ADDENDUM NO. 1
February 26, 2021
224126

RE: **CITY OF BARRE, VERMONT**
BIOSOLIDS IMPROVEMENTS PROJECT

FROM: DuBOIS & KING, INC.
P.O. Box 339
Randolph, Vermont 05060
(802) 728-3376

C4

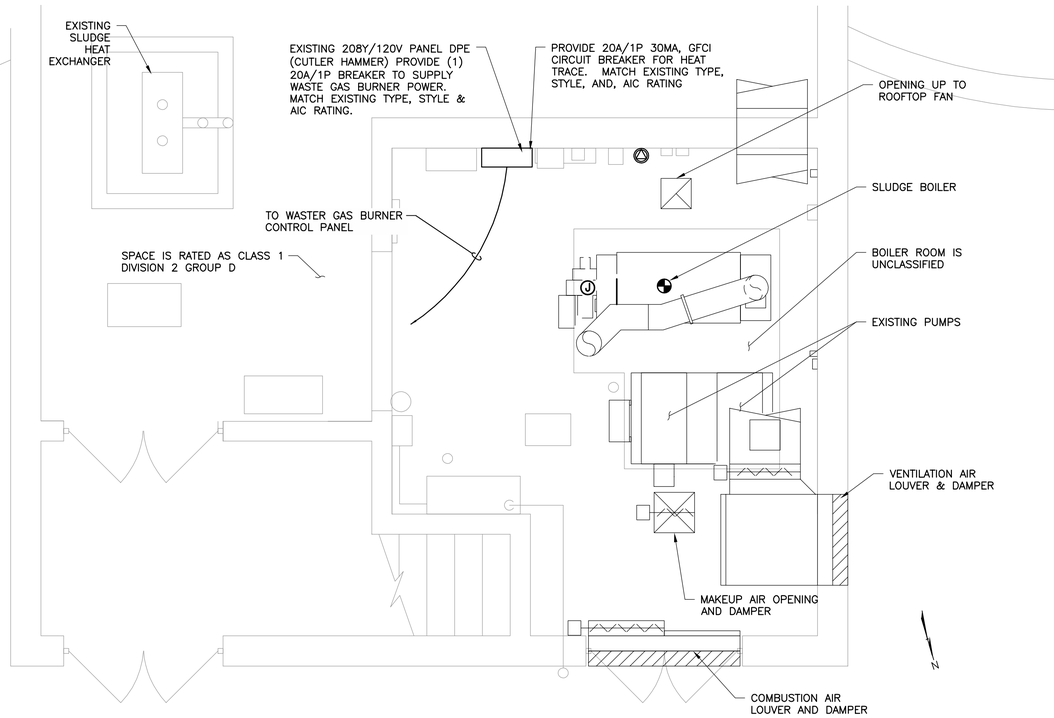
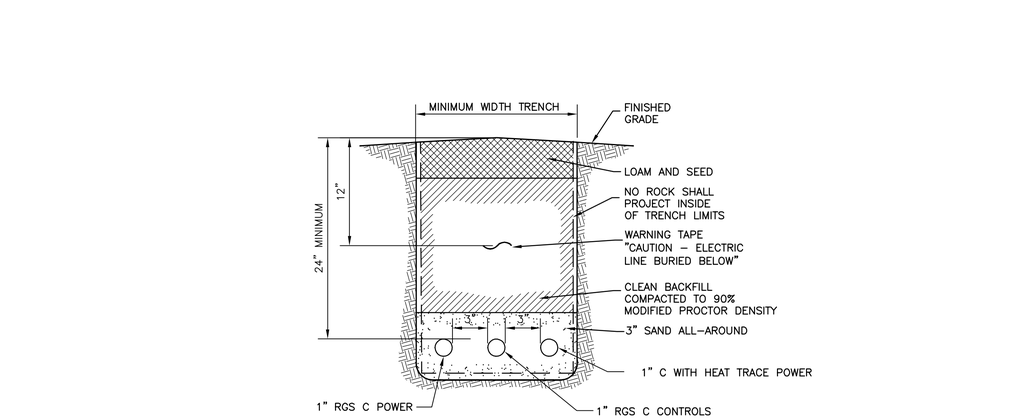
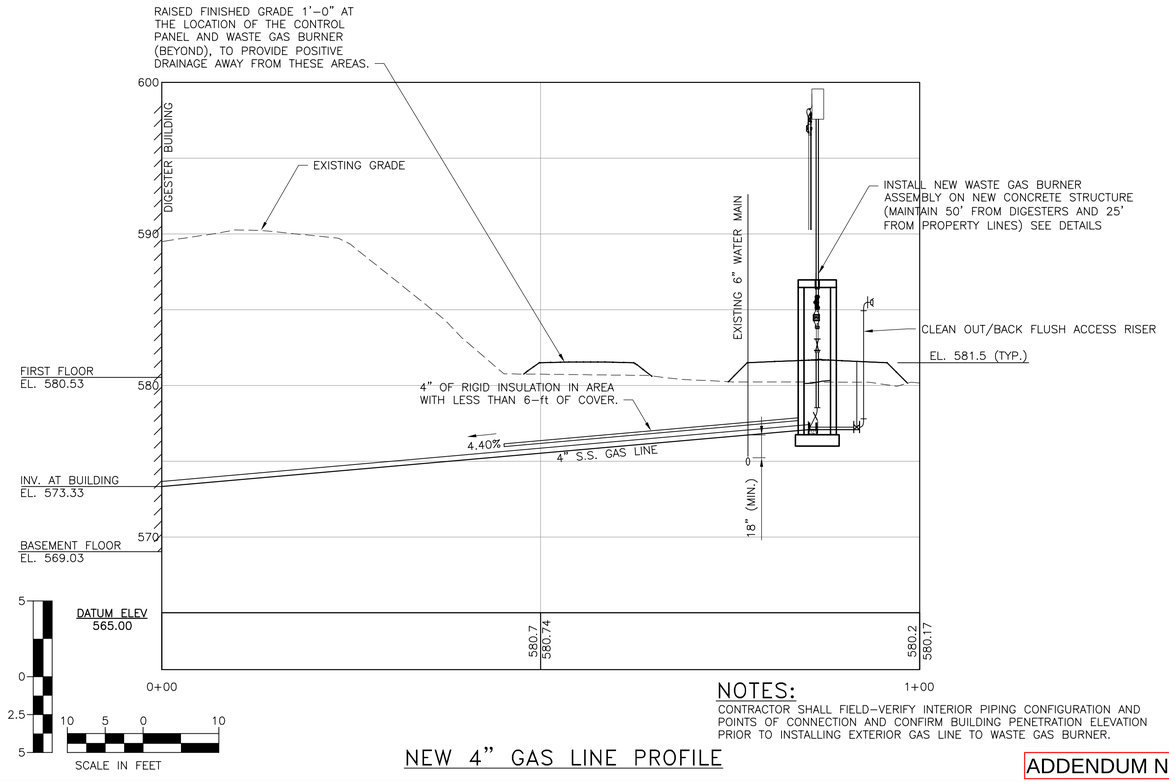
1. Reissue sheet C4. See **Attachment 3**.

C6

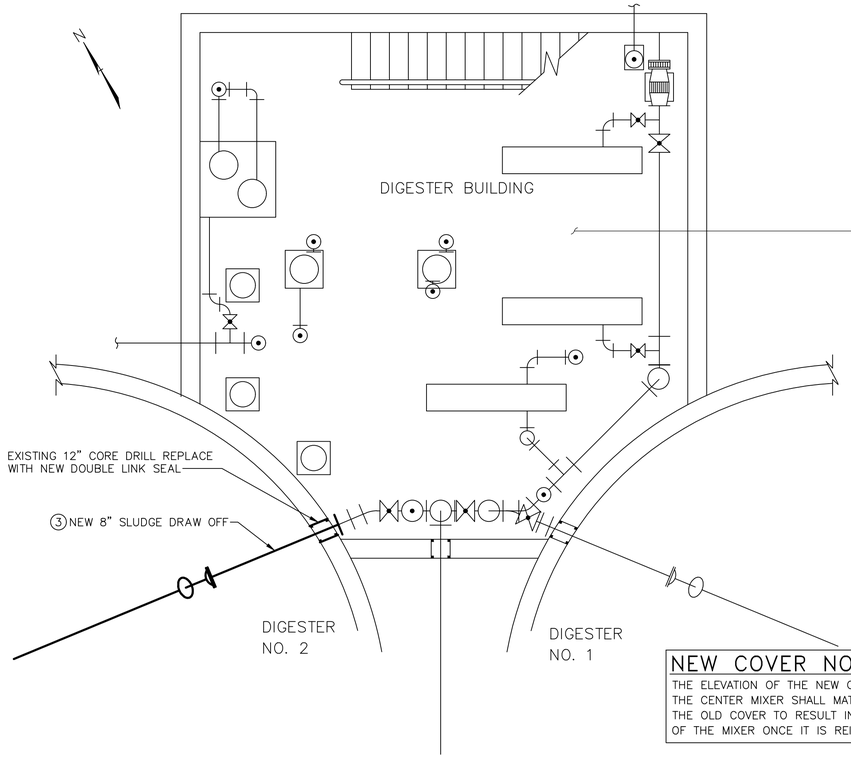
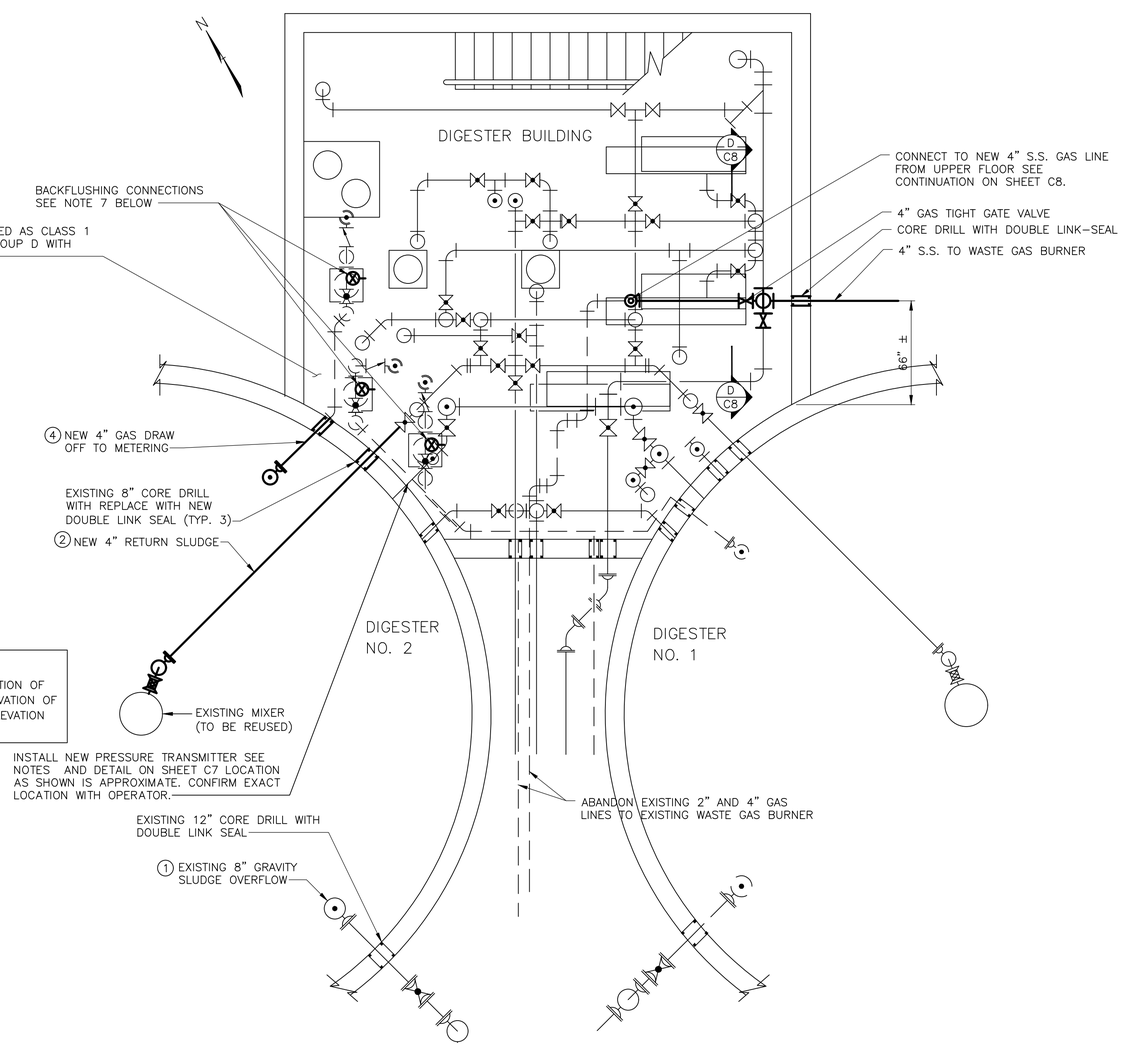
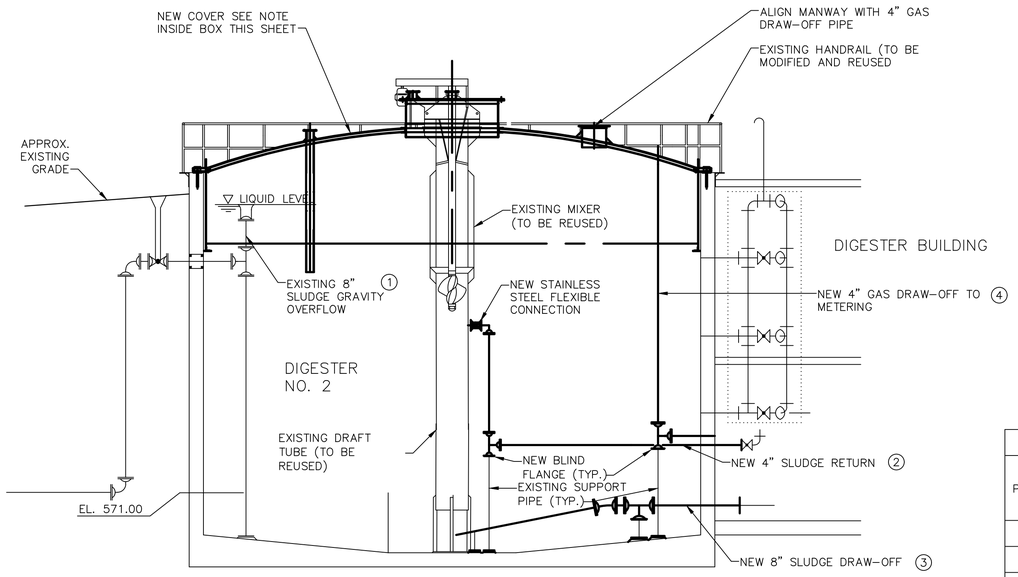
2. On Sheet C5 add note stating "CUT AND CAP 2" PVC PILOT LINE AND 4" D.I. WASTE GAS LINE AT WALL PENETRATION" to "SLUDGE/GAS PIPING PLAN ABOVE ELEV. 571.00".

3. Reissue sheet C6. See **Attachment 3**.

C8

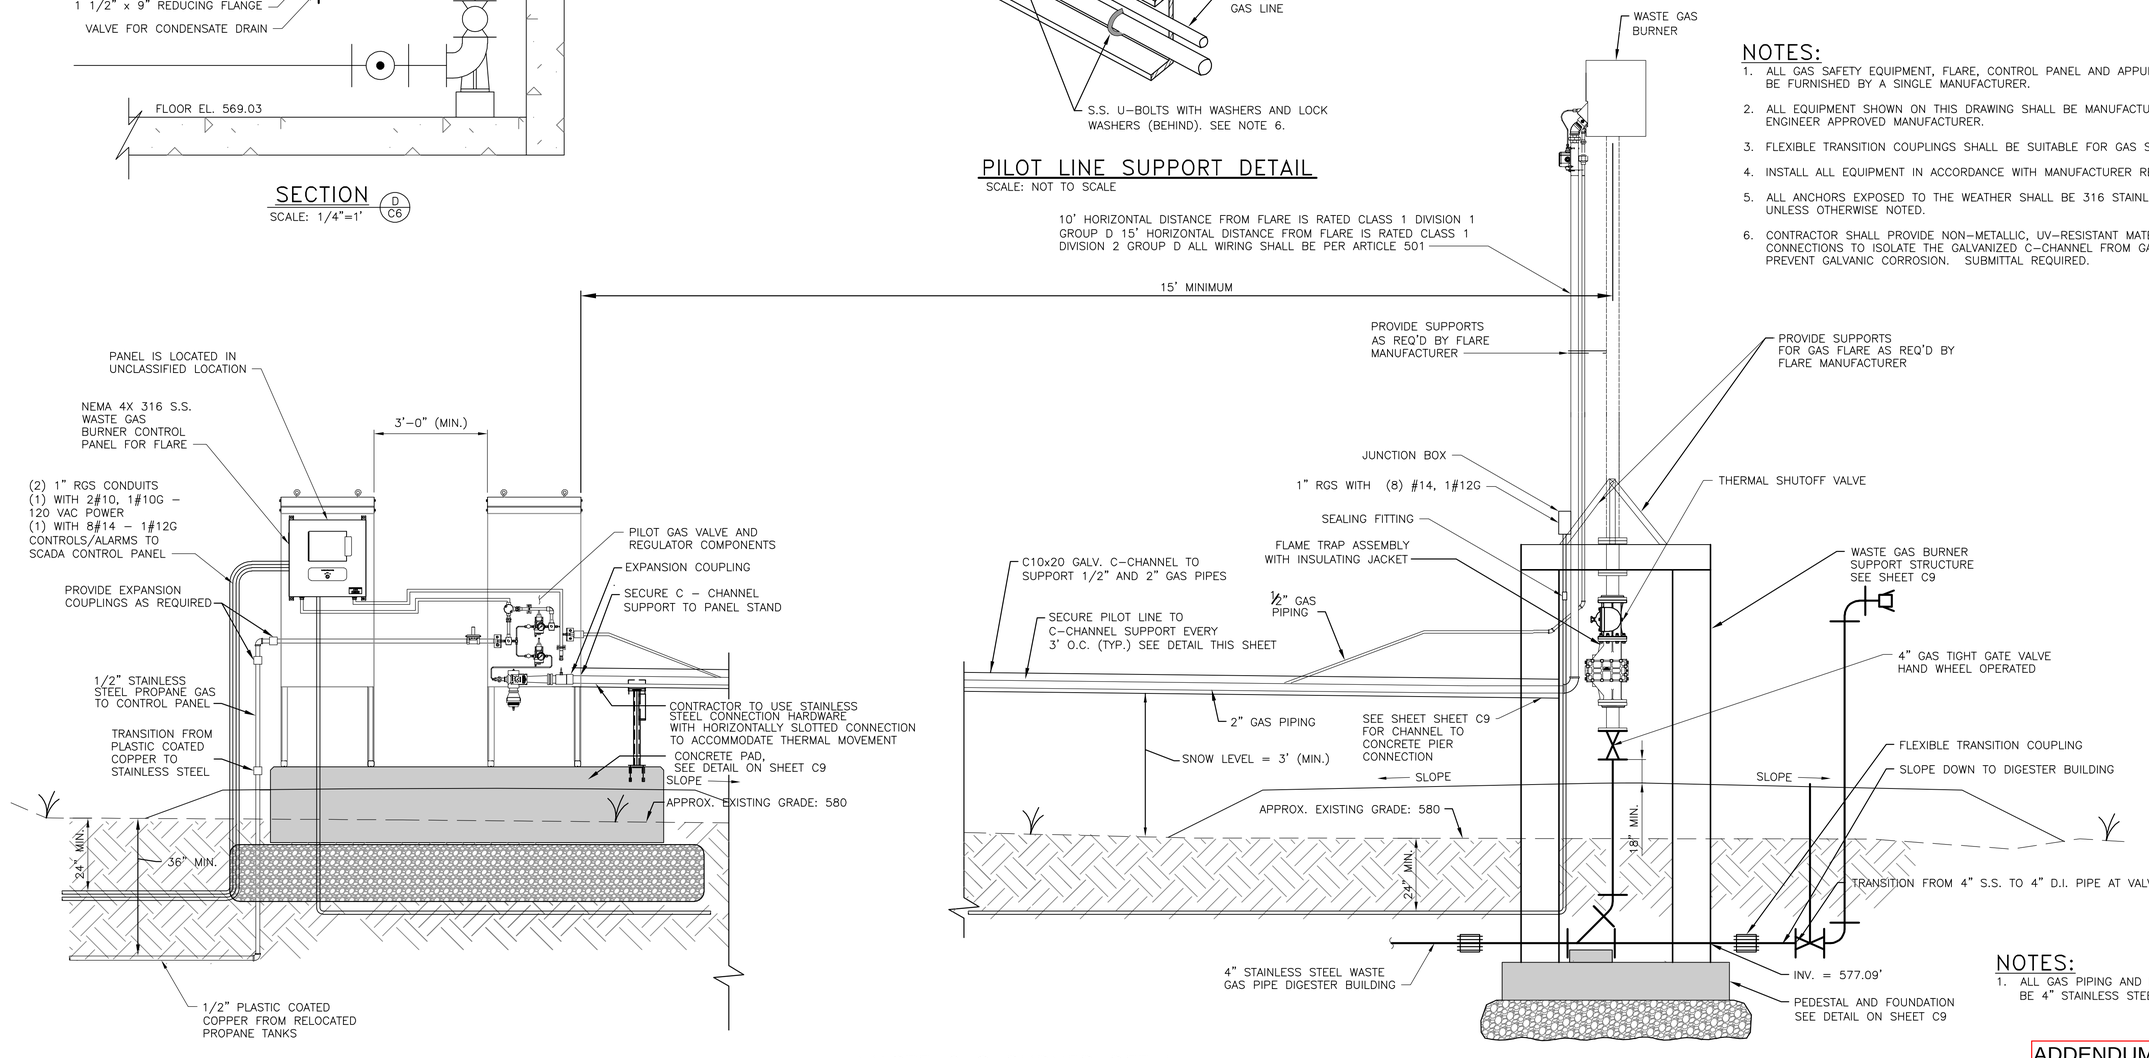
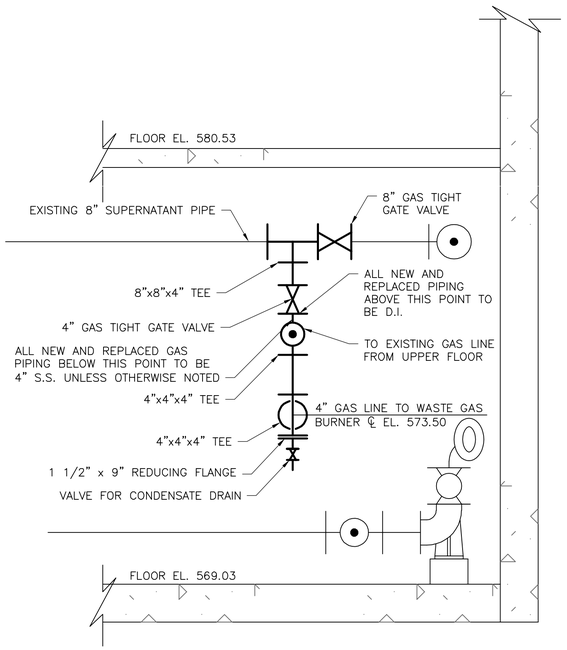
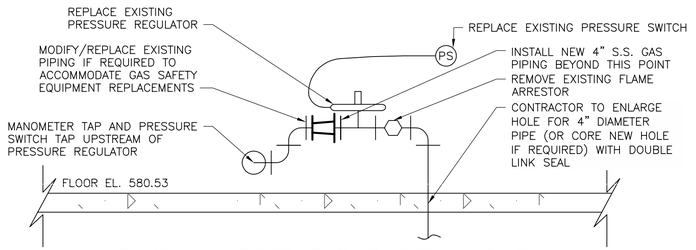
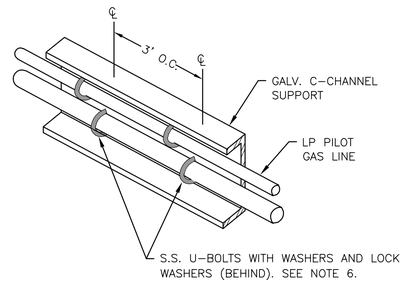
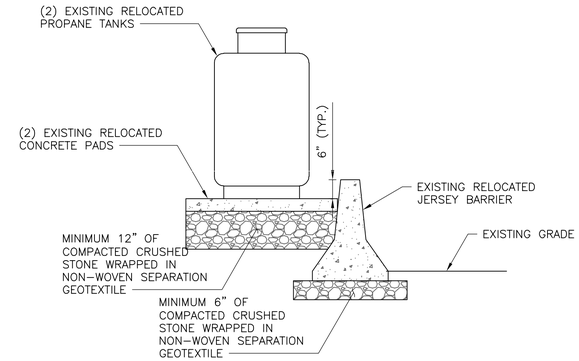
Question 12: In reference to **Sheet C8**, will support piers be required to support the 10" channel?

5. Reissue sheet C8. See **Attachment 3**.

Answer 12: The channel was sized/designed to span the identified length. The channel is attached to the concrete pier on one end. The reissued Sheets C8 and C9 identify a support on the concrete pad associated with the Gas Burner Control Panel.
